ST/SG/AC.10/21/Add.4
8 February 1995

COMMITTEE OF EXPERTS ON THE TRANSPORT
OF DANGEROUS GOODS

REPORT OF THE COMMITTEE OF EXPERTS ON ITS EIGHTEENTH SESSION
(28 November - 7 December 1994)

Annex 4 : Report of the Working Group on the Rationalization of the Manual of Tests and Criteria.

Figure 11.1: TEST PLATE AND IGNITION WIRE

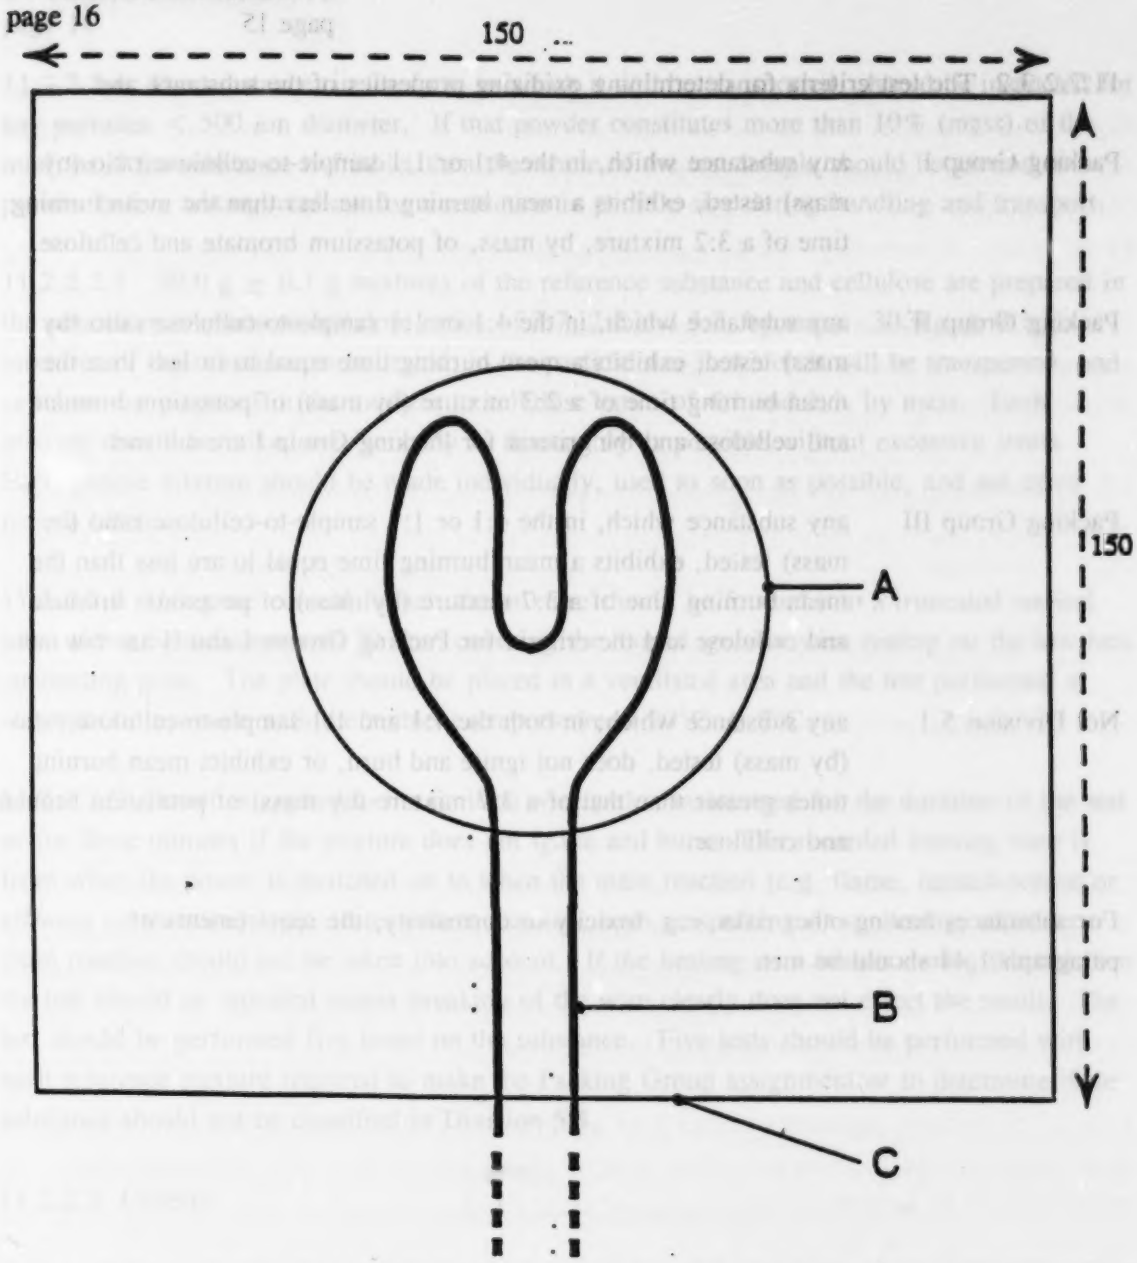
Figure 11.1 Renumber figure 11.1 to figure 11.2 and replace it with figure given in the annex to United Kingdom document -/C.3/R.437.

Figure 14.4: CLASSIFICATION OF SELF-HEATING SUBSTANCES

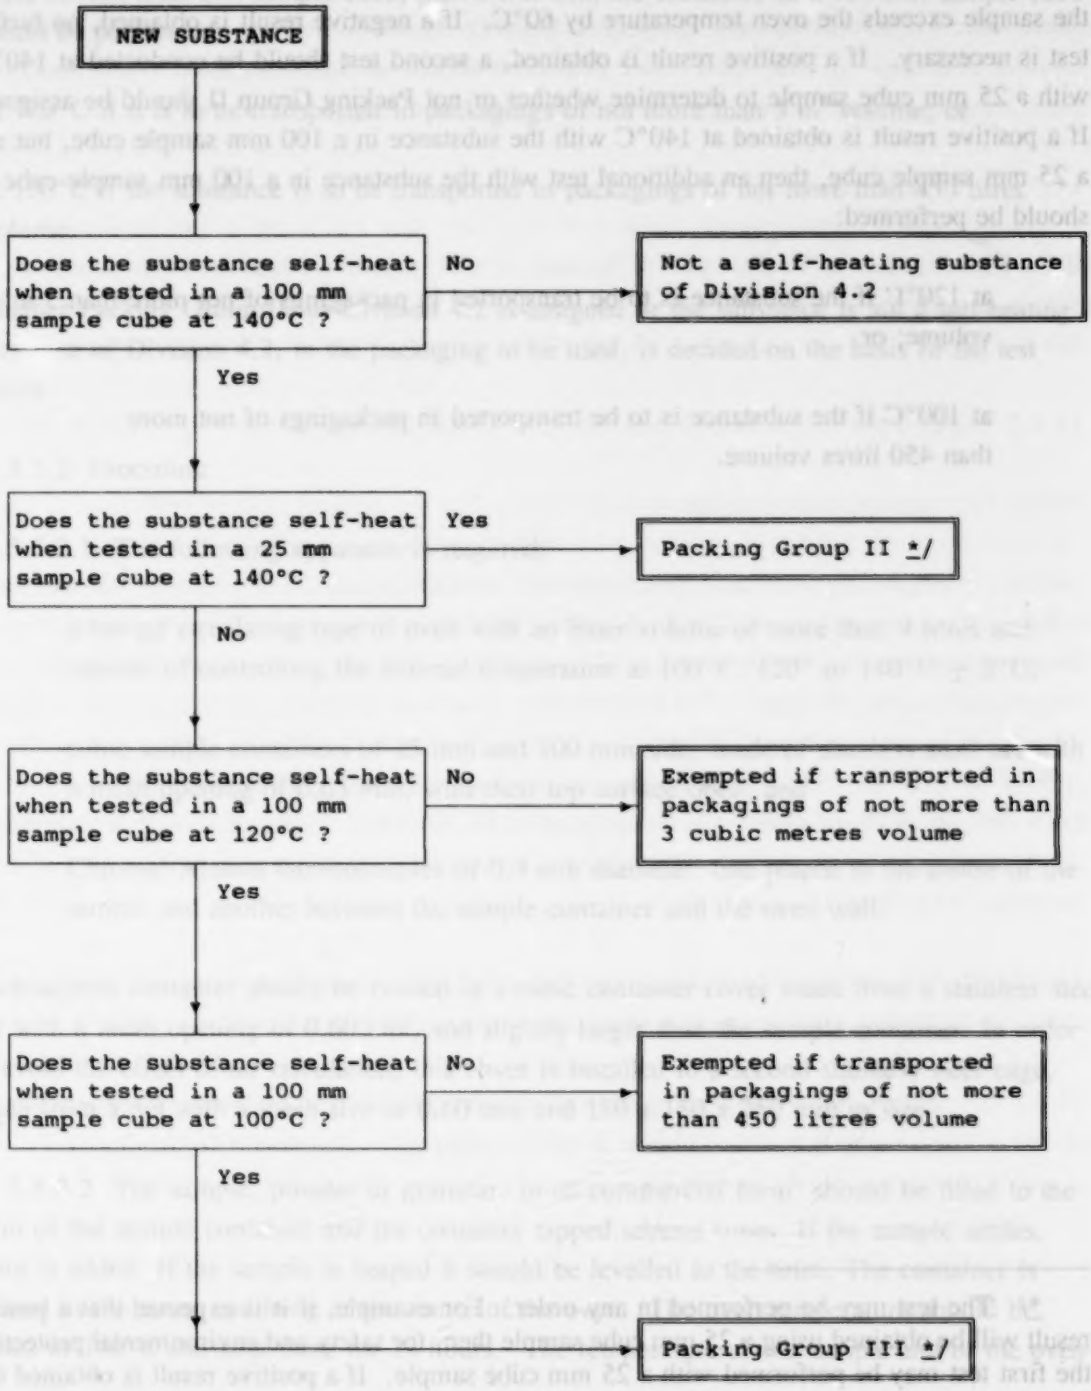
14.5.5 Replace the text of sub-section 14.5.5 with the following:

Figure 28.4.2.2 & 28.4.3.2: EXAMPLE OF DETERMINATION OF SADT

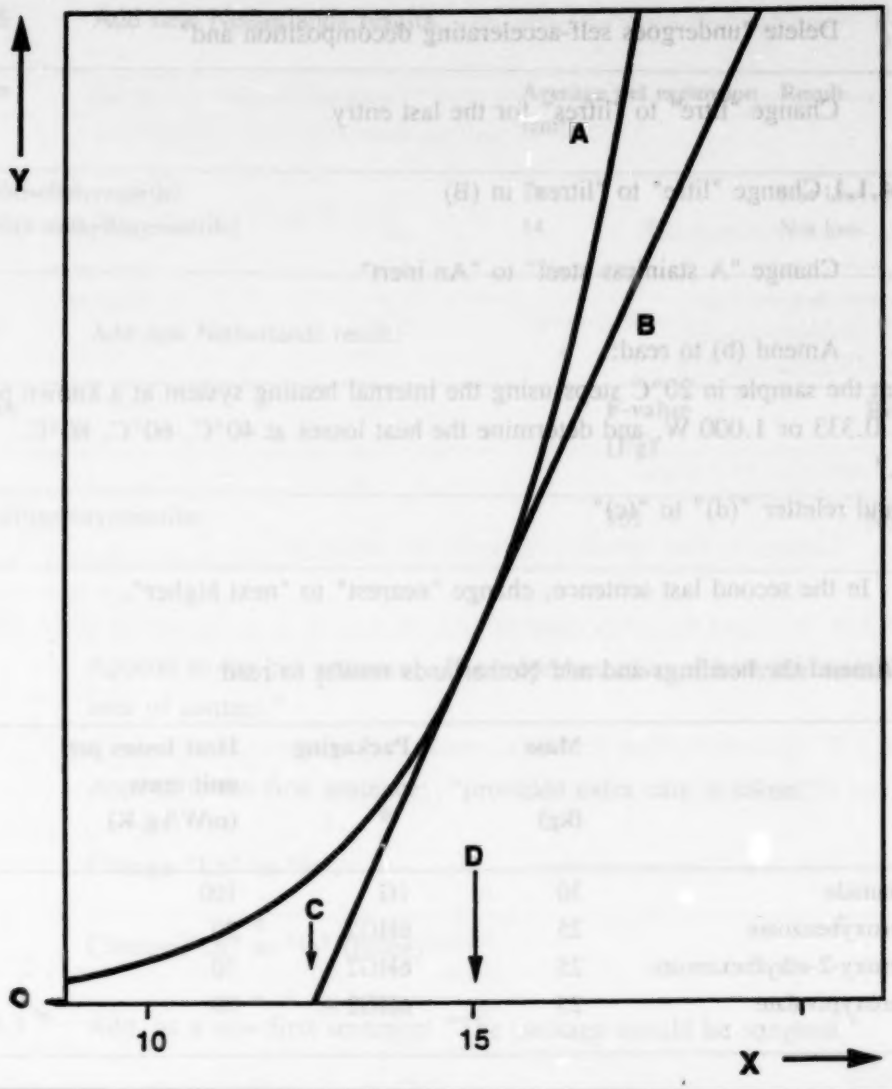
Figure 28.4.2.2 and **Figure 28.4.3.2** replace with following new figure.
